SUB-COMMITTEE ON SHIP SYSTEMS AND  
EQUIPMENT  
10th session  
Agenda item 17

SSE 10/17/1  
15 November 2023  
Original: ENGLISH  
Pre-session public release:

### Proposal to include the output "Review and update SOLAS regulation II-2/9 on containment of fire to incorporate existing guidance and clarify requirements" in the provisional agenda for SSE 11

Submitted by IACS

Regulation 9.2.2.1.4: Arrangement of Main vertical zones

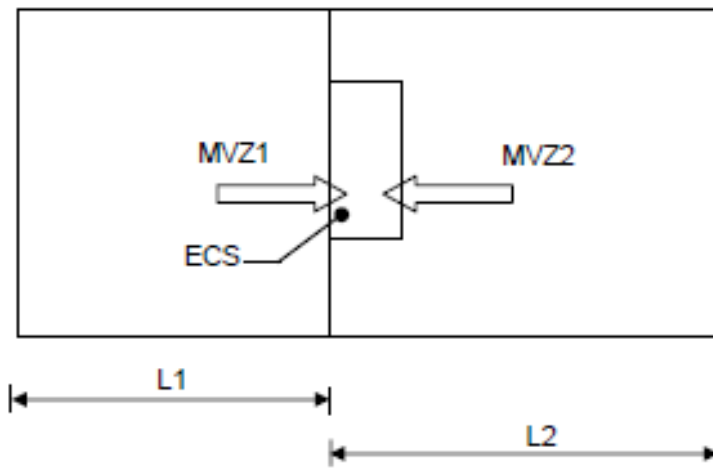
<b>SOLAS II-2/9</b>	<b>Topic</b>	<b>IMO reference document</b>	<b>Action</b>
9.2.2.1.3 bis (new)	Main vertical zones.	MSC/Circ.1120	<i>Added text from MSC/Circ.1120. The figures from MSC/Circ.1120 is proposed moved to a new circular containing explanatory figures to SOLAS regulation II-2/9.</i>

2.2.1.3.1 If a stairway serves two main vertical zones, the maximum length of one main vertical zone is to be measured from the far side of the main vertical zone stairway enclosure. In this case, all boundaries of the stairway enclosure are to be insulated as main vertical zone bulkheads and access doors leading into the stairway are to be provided from the zone. However, the stairway is not to be included in calculating the size of the main vertical zone if it is treated as its own main vertical zone.\*

\* (Refer to figures in a new MSC circular, proposed to be developed).
